Office Action Summary

10/642,365

DETAILED ACTION

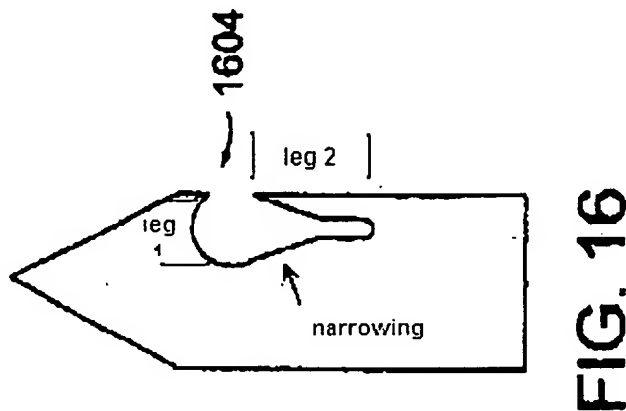
Claims 9-13, 18-21 and 26, ^{are}rejected under 35 U.S.C. 103(a) as being unpatentable over Giesy et al. (US 5152749) in view of Skiba et al. (US 6723107). Giesy teaches an implant placement device comprising the following:

- a connector pair (44, 46) for attaching a medical implant (40) to a delivery device

- the connector pair comprising, a closed loop connector (44) located at an end of a medical implant (40)
- a slotted connector (46) formed in a distal end (20b) of a shaft (20) of a delivery device (10)

- for interfitting with the closed loop connector of the medical implant (fig. 3)
- wherein the closed loop connector is capable of being substantially triangular in shape. It is noted that the closed loop connector is formed of a filamentous material, which is inherently malleable into any shape including triangular.

- a freely slidable tubular sleeve (22) on the shaft for sliding over and covering the slotted connector subsequent to interfitting the closed loop connector with the slotted connector (fig. 4).

Geisy fails to disclose wherein the slotted connector includes first and second legs, the first leg extending radially into the shaft and the second leg extending axially in

a distal direction along the shaft and includes a narrowing for locking the looped connector into the second leg.
